re: Geotechnical Grading and Site Servicing Plans Review
Proposed Industrial Development
295 Roger Neilson Way - Ottawa, Ontario

date: August 27, 2026

file: PG7845-MEMO.02

SITE SERVICING PLAN

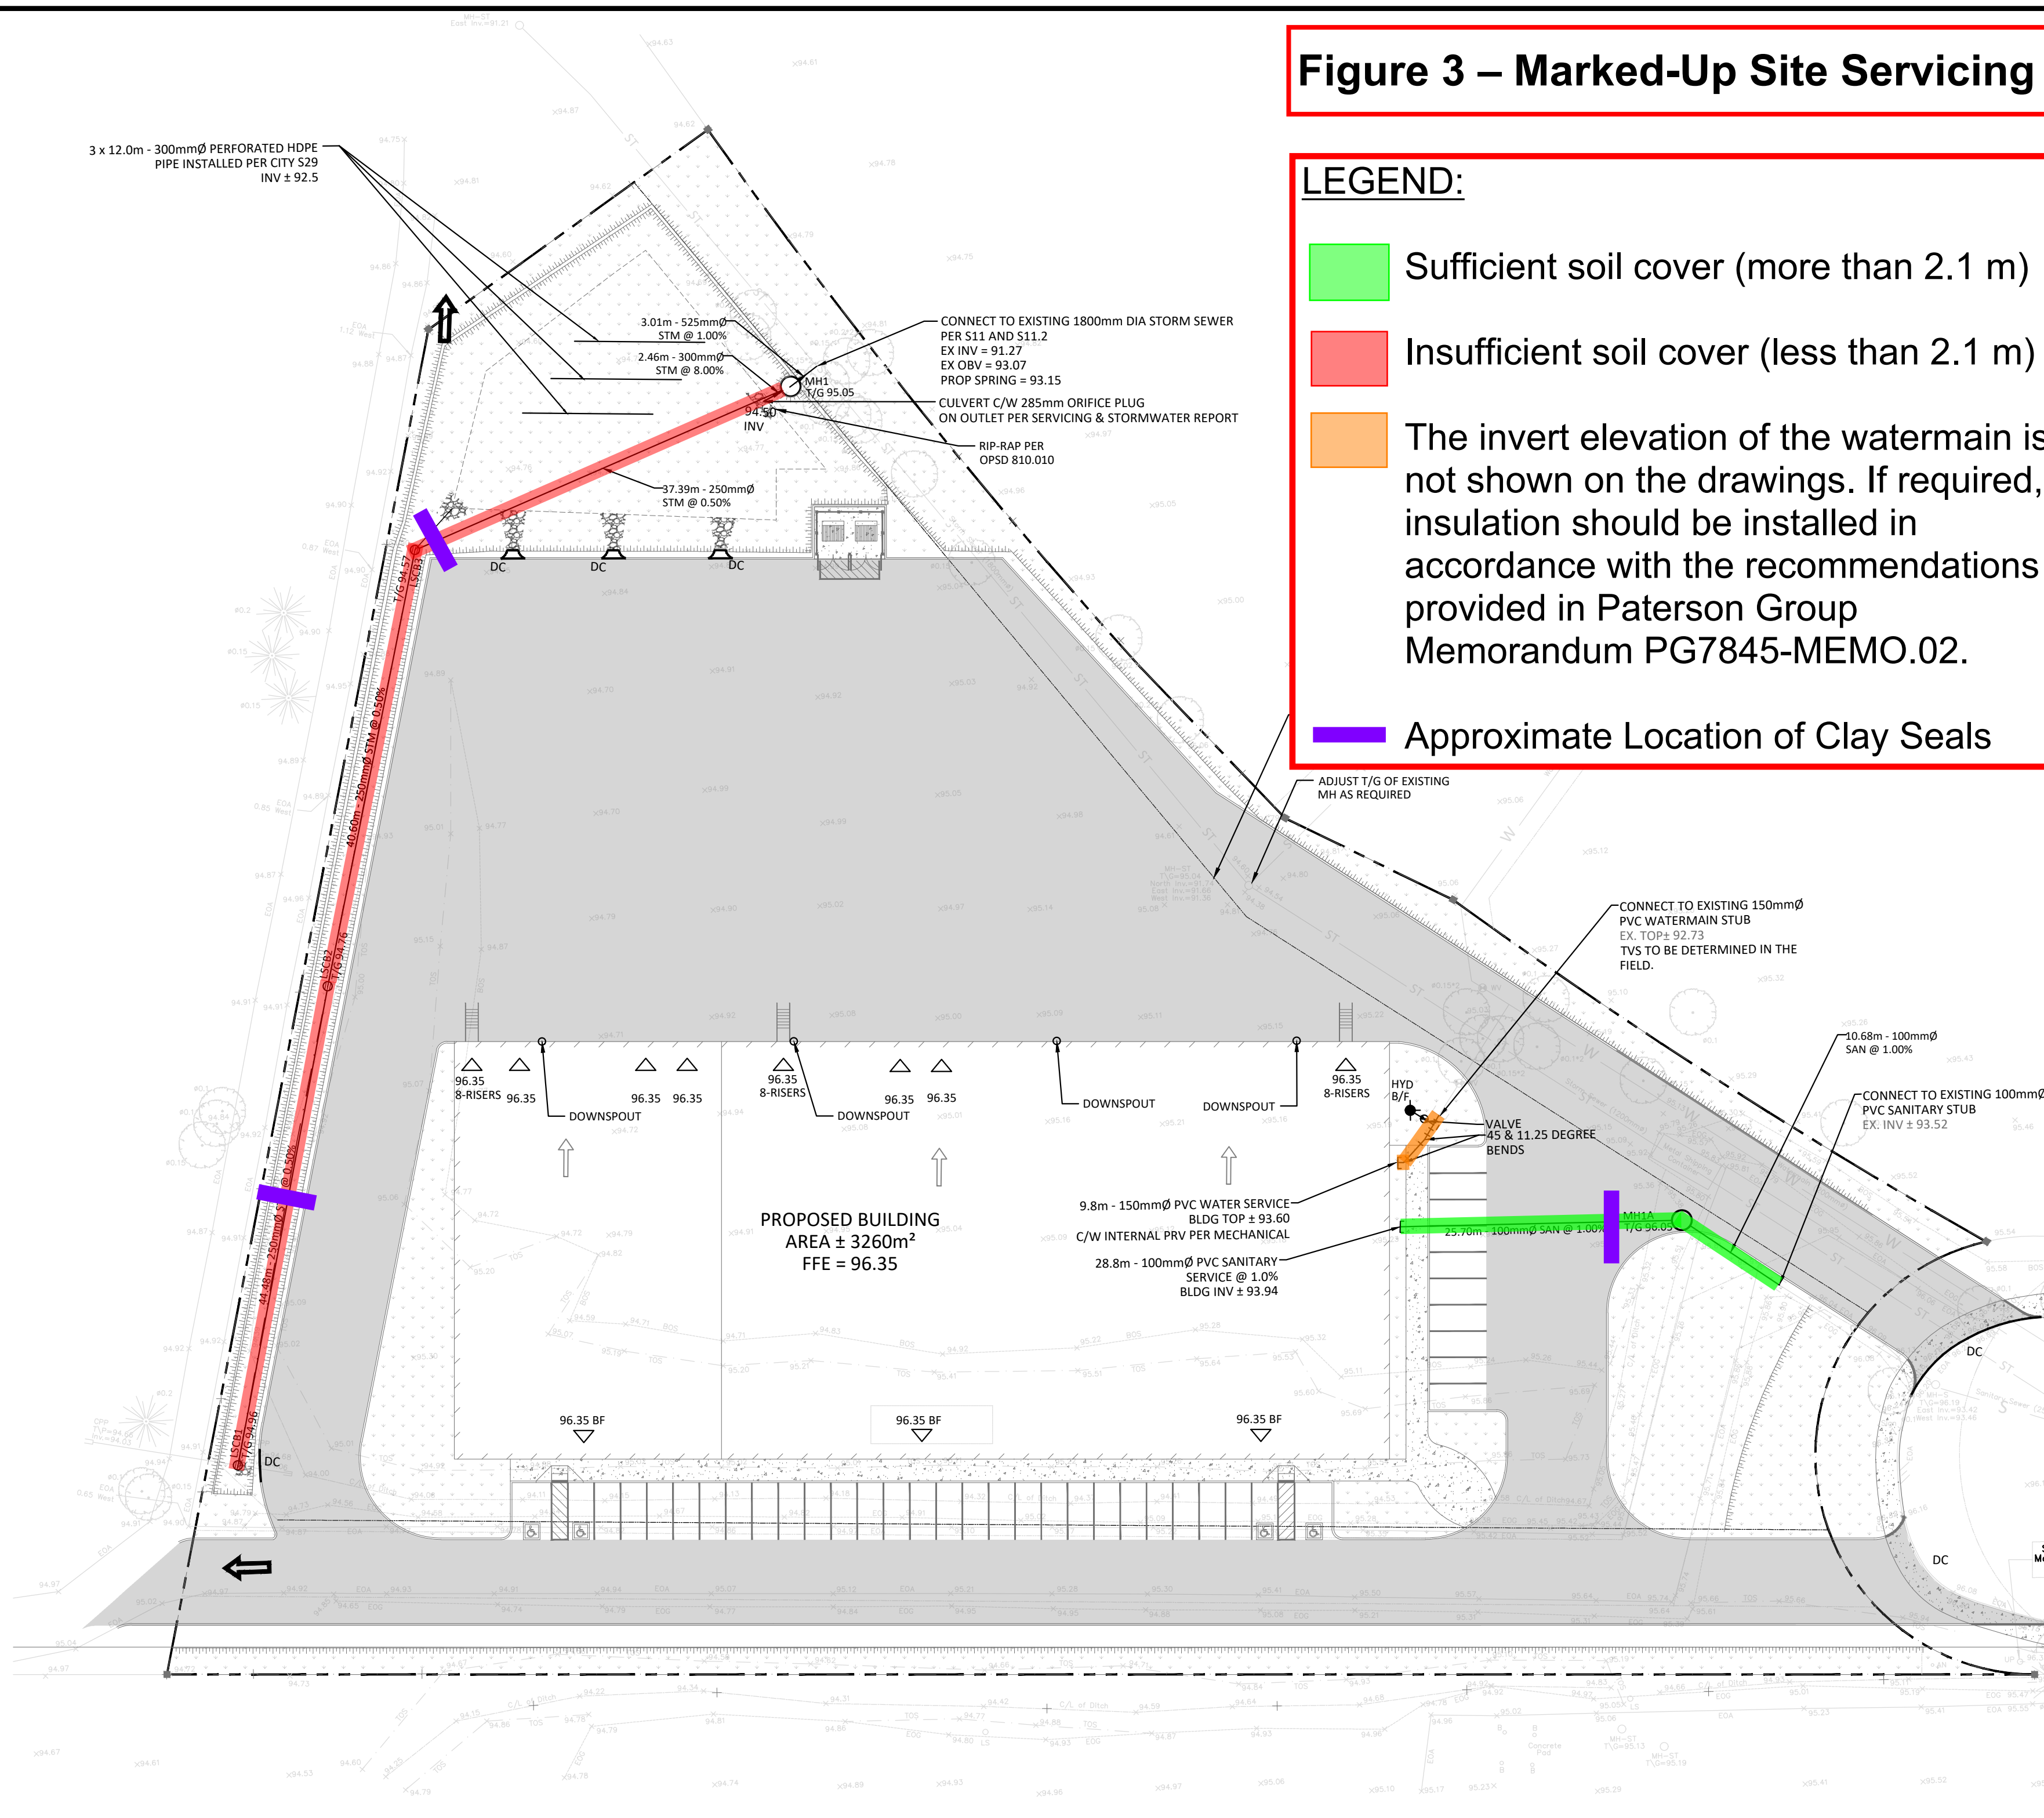
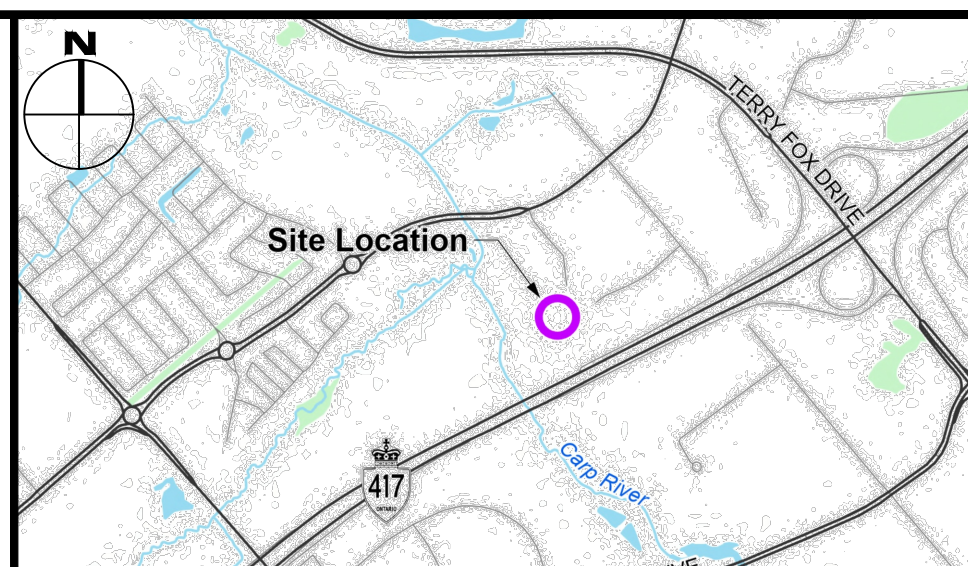
Based on our review of the above-noted site service plans, it should be noted that all services will be constructed outside the lateral zones of the proposed footings of the building and are considered to be acceptable from a geotechnical perspective. However, insufficient frost protection has been provided for all proposed storm sewer pipes throughout the subject site. The proposed services are located within the frost zone, approximately 2.1 m below the finished grade. In the following section, frost protection of the site servicing is recommended where insufficient frost cover has been provided.

Reference should be made to Figure 3 – Marked-Up Site Servicing Plan, attached to the current memorandum, for the location of pipes where insulation will be required.

It should be noted that the invert elevation of the watermain pipes has not been presented in the above-noted site servicing drawings. Therefore, if insufficient soil cover is provided for watermain pipes, rigid insulation should be installed for the proposed watermain pipes as recommended in the above table (Table 1).

In addition, to reduce long-term lowering of the groundwater at this site, clay seals should be provided within the service trenches excavated through the silty clay deposit. The seals should be at least 1.5 m long (in the trench direction) and should extend from trench wall to trench wall. The seals should extend from the frost line and fully penetrate the bedding, subbedding, and cover material. The barriers should consist of relatively dry and compactable brown silty clay placed in maximum 300 mm thick loose layers and compacted to a minimum of 95% of the SPMDD. The clay seals should be placed at the site boundaries and at strategic locations at no more than 60 m intervals in the service trenches excavated through the silty clay deposit.

Reference should be made to Figure 3 – Marked-Up Site Servicing Plan, attached to the current memorandum, for the approximate location of clay seals at the subject site.

Insufficient soil cover (less than 2.1 m)

The invert elevation of the watermain is not shown on the drawings. If required, insulation should be installed in accordance with the recommendations provided in Paterson Group Memorandum PG7845-MEMO.02.

Approximate Location of Clay Seals

TYPICAL FROST INSULATION DETAIL

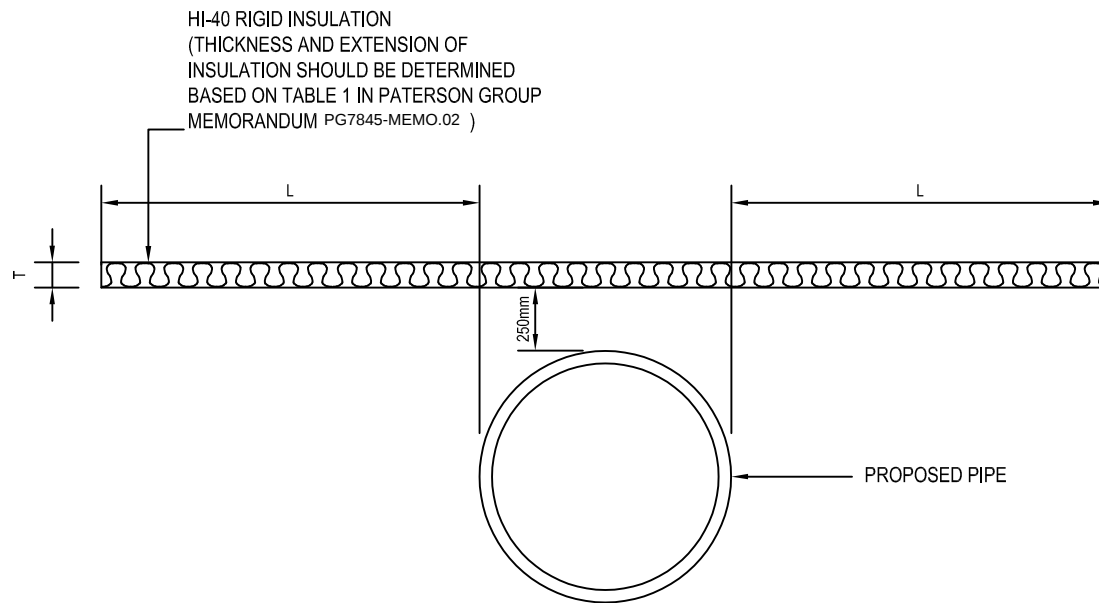
Any portion of the services installed at a depth of 2.1 m below finished grade or deeper is considered to have sufficient soil cover for frost protection. Where insufficient soil cover is present above the invert of storm sewer pipe, the following frost protection criteria should be followed:

All rigid insulation should consist of either Dow Chemical High-Load 40 (HI-40), Styro Rail SR.P400, or equivalent approved by Paterson. The placement of all insulation within the service trenches must be reviewed and approved by Paterson personnel at the time of construction. Reference should be made to Figure 4 – Typical Frost Insulation Detail, attached to this memorandum.

Table 1 - Rigid Insulation Recommendations for Pipes with Reduced Soil Cover			
Thermal Condition	Soil Cover Provided (mm)	Insulation Dimensions	
		Thickness (mm)	Extension (mm)
Unheated	600 to 900	125	Extend 1200 mm horizontally beyond edge face of the pipe
	900 to 1200	100	Extend 1200 mm horizontally beyond edge face of the pipe
	1200 to 1500	75	Extend 900 mm horizontally beyond edge face of the pipe
	1500 to 1800	50	Extend 600 mm horizontally beyond edge face of the pipe
	1800 to <2100	25	Extend 300 mm horizontally beyond edge face of the pipe
Notes: All designs are based on a freezing index of 1000°C-days
